# V3 - SDP-23-04

7- ELEVEN 9350 CST  
 US 401 BUSINESS / S. MAIN STREET & VIRGINIA WATER DRIVE  
 ROLESVILLE, NC

**Drawing Size:** 30 x 42  
**Project #:** 22050  
**Drawn By:** MBN  
**Checked By:** CCMB  
**Title:** EXTERIOR COLORED ELEVATIONS

**Sheet Number:** A3.3  
**Date:** 04/27/23 **Store #:** 42337

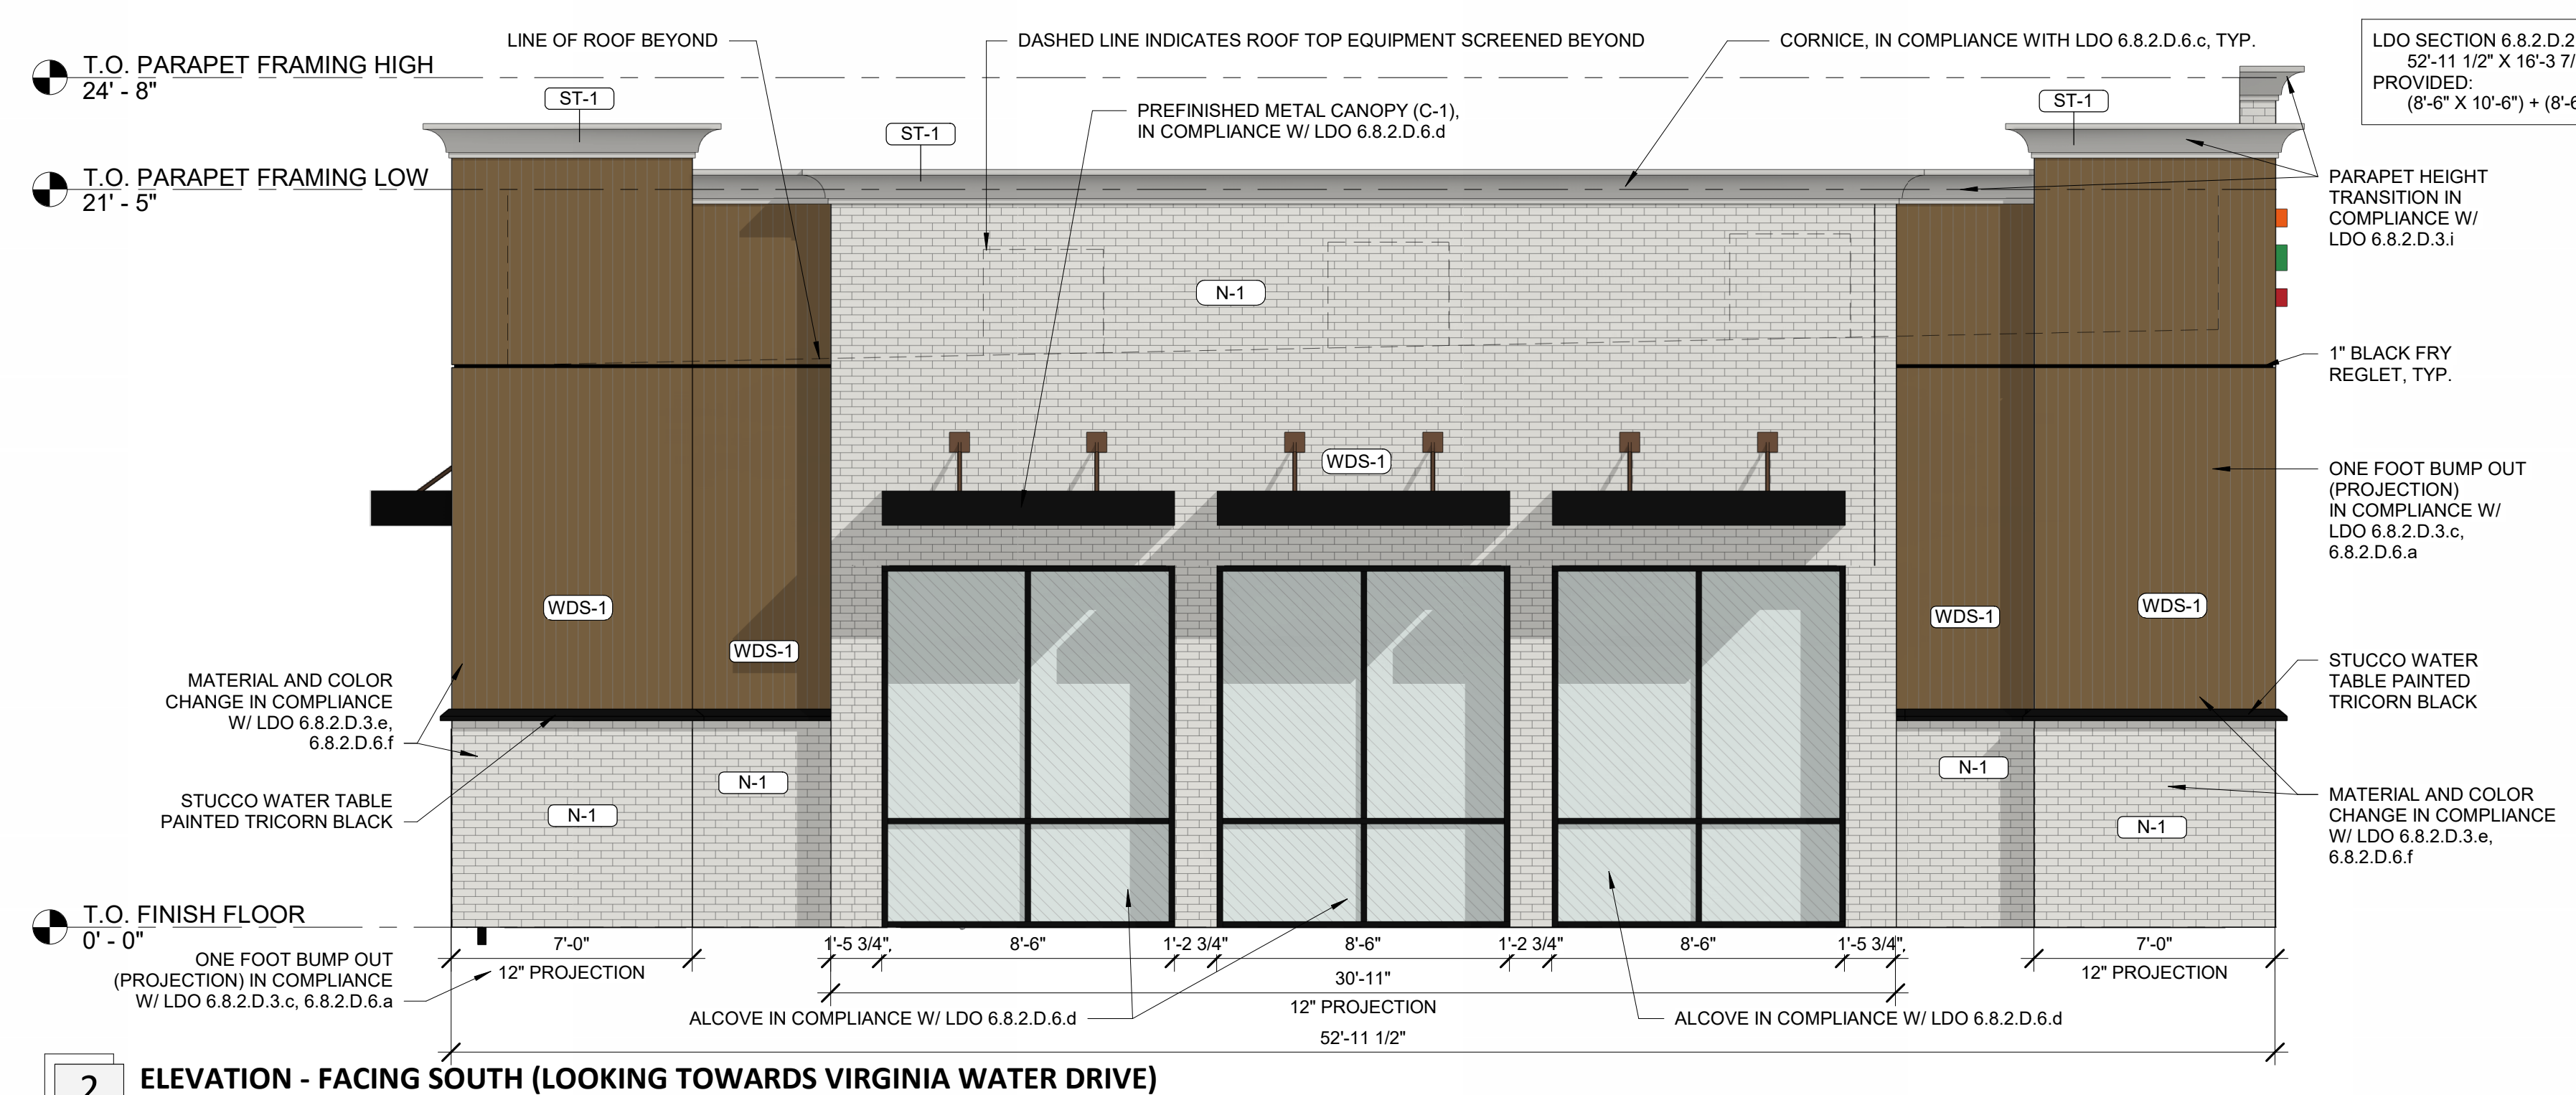
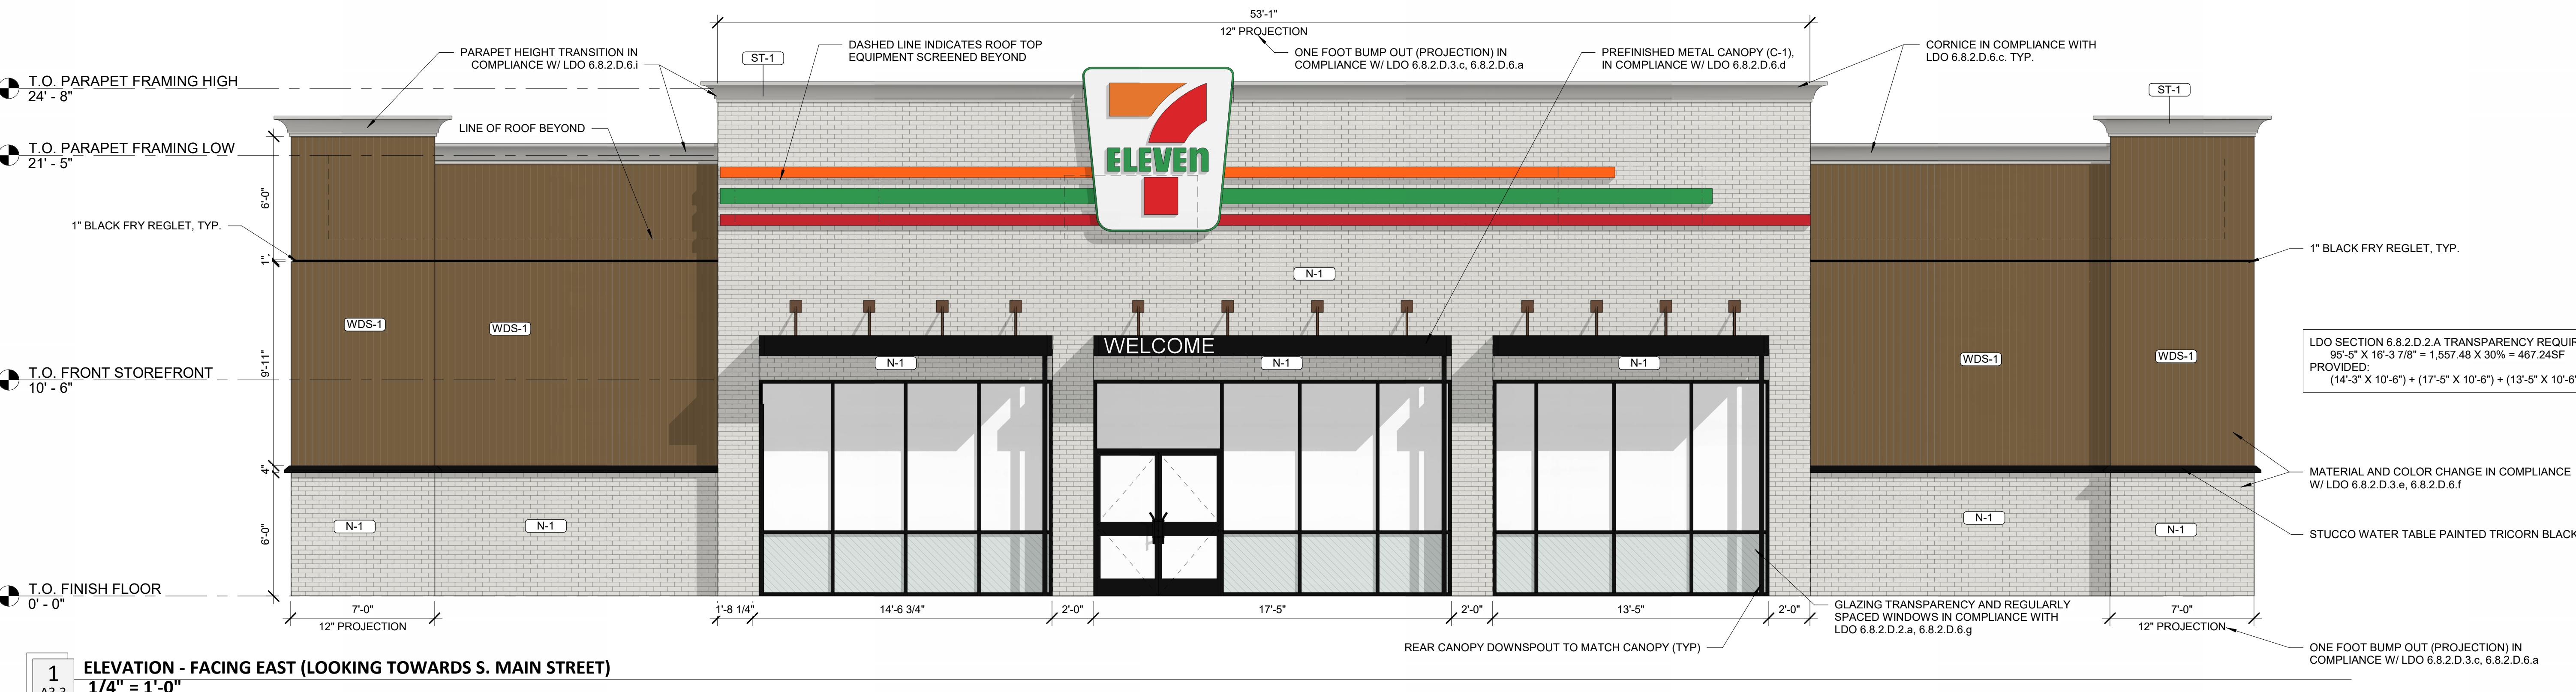
Blank wall area is regulated per LDO Section 6.8.2.C.1. See written comment.

To ensure visually interesting buildings of high-quality visual design, a minimum of four (4) design items noted in LDO Section 6.8.2.D.6 shall be utilized in building design.

**COMMENT #10:** LDO SECTION 6.8.2.B. - APPLICABILITY - BUILDING DESIGN STANDARDS SHALL BE REQUIRED ON ALL WALLS OF A BUILDING THAT FACE A PUBLIC STREET OR RIGHT-OF-WAY. THIS SECTION THUS APPLIES TO THE WALLS OF THE PROPOSED BUILDING FACING MAIN STREET AND VIRGINIA WATER DRIVE ONLY.  
 RESPONSE: ACKNOWLEDGED. SEE UPDATED EXTERIOR ELEVATIONS FACING MAIN STREET AND VIRGINIA WATER DRIVE.

**COMMENT #11:** LDO SECTION 6.8.2.C.1 AND 6.8.2.D.3 - BLANK WALL AREA - DEFINED AS "BLANK WALL AREAS ARE PORTIONS OF AN EXTERIOR FAÇADE THAT DOES NOT INCLUDE WINDOWS, DOORS, COLUMNS, PILASTERS, ARCHITECTURAL FEATURES GREATER THAN ONE (1) FOOT IN DEPTH, OR A SUBSTANTIAL MATERIAL CHANGE."

A. 6.8.2.D.3.A - PAINT IS NOT CONSIDERED A SUBSTANTIAL MATERIAL CHANGE.  
 B. 6.8.2.D.3.C - THE MAXIMUM CONTINUOUS BLANK WALL AREA FOR ANY BUILDING SHALL BE A MAXIMUM FIFTY (50) SQUARE FEET WITHOUT A BREAK BY WINDOWS, DOORS, ARCHITECTURAL FEATURES GREATER THAN ONE (1) FOOT IN DEPTH, OR A SUBSTANTIAL MATERIAL CHANGE, UNLESS EXPLICITLY STATED ELSEWHERE IN THIS LDO.

C. SEE MARK-UP - REVISE DRAWING TO PROVIDE DIMENSIONS THAT SHOW/PROVE EITHER THERE ARE NO BLANK WALL AREAS, OR REVISE DRAWINGS TO BREAK UP THE TECHNICALLY BLANK WALL AREAS.

D. NOTE: IF THESE BLANK WALL AREAS ARE THE INTENDED LOCATIONS OF (FUTURE) SIGNS, DRAW IN 'BOXES' FOR 'FUTURE SIGN HERE' AND EXPLAIN IF THAT THOSE SIGNS WILL BE DIMENSIONAL AND MEET THE INTENTS OF THE ARCHITECTURAL MEANS TO BREAK UP A BLANK WALL AREA, BUT WITH SIGNAGE RATHER THAN ARCHITECTURE.

**COMMENT #12:** LDO SECTION 6.8.2.D.2 - REVISE SHEET A3.3 TO DEMONSTRATE COMPLIANCE. GROUND FLOOR TRANSPARENCY SHALL BE CALCULATED BASED ON THE TOTAL FAÇADE AREA LOCATED BETWEEN THE FINISH GROUND FLOOR LEVEL AND BEGINNING OF THE UPPER FLOOR. ALL GROUND FLOOR TRANSPARENCY SHALL BE A MINIMUM THIRTY (30) PERCENT, UNLESS STATED OTHERWISE IN THIS LDO.  
 RESPONSE: SHEET A3.3 AND A3.4 HAS BEEN UPDATED TO INCLUDE TRANSPARENCY INFORMATION CONCERNING THE ELEVATION FACING MAIN STREET AND VIRGINIA WATER DRIVE. IN ACCORDANCE WITH LDO SECTION 6.8.2.D.2, THE TRANSPARENCY HAS A MINIMUM OF 30%.

**COMMENT #13:** LDO SECTION 6.8.2.D.6 - REVISE SHEET A3.3 TO PROVIDE/SHOW MINIMUM OF FOUR (4) DESIGN ITEMS NOTED IN THIS SECTION TO ENSURE VISUALLY INTERESTING BUILDINGS OF HIGH-QUALITY VISUAL DESIGN.  
 RESPONSE: SEE SHEET A3.3 AND A3.4 FOR CHANGES MADE IN ACCORDANCE WITH LDO SECTION 6.8.2.D.6. THE FOLLOWING DESIGN ITEMS HAVE BEEN ADDED TO COMPLY WITH 6.8.2.D.6 LETTERS A, C, D, E, F, G, AND I. BUMP OUTS, CHANGES IN HEIGHT OF MATERIAL, MATERIAL CHANGES, AWNINGS, CORNICES, AND ALCOVES.

Blank wall areas have been revised. Please see updated elevations and comment responses on this sheet.

A minimum of 4 design items have been incorporated. Please see updated elevations and comment responses on this sheet.

RESPONSE: ACKNOWLEDGED. SEE UPDATED EXTERIOR ELEVATIONS FOR COMPLIANCE TO LDO SECTION 6.8.2.C.1 AND 6.8.2.D.3. ONE FOOT DEEP BUMP OUTS WERE ADDED TO ALL FOUR CORNER OF THE BUILDING TO ELIMINATE THE BLANK WALL AREAS AND ADD HORIZONTAL AND VERTICAL BREAKS.

A. ACKNOWLEDGED. SEE EXTERIOR ELEVATIONS FOR COMPLIANCE WITH LDO SECTION 6.8.2.D.3.A THAT DEMONSTRATE MATERIAL CHANGES AS REQUIRED.  
 B. SEE UPDATED EXTERIOR ELEVATIONS FOR COMPLIANCE WITH LDO SECTION 6.8.2.D.3.C. THE FOLLOWING DESIGN ITEMS HAVE BEEN ADDED TO COMPLY WITH 6.8.2.D.6 LETTERS A, C, D, E, F, G, AND I. BUMP OUTS, CHANGES IN HEIGHT OF THE WALL, MATERIAL CHANGES, AWNINGS, CORNICES AND ALCOVES.

C. SEE UPDATED EXTERIOR ELEVATIONS FOR REVISED DEPTH CHANGES AND HORIZONTAL AND VERTICAL BREAKS. DIMENSIONS HAVE BEEN PROVIDED FOR MINIMUM ONE FOOT DEPTH CHANGE.

D. ACKNOWLEDGED.
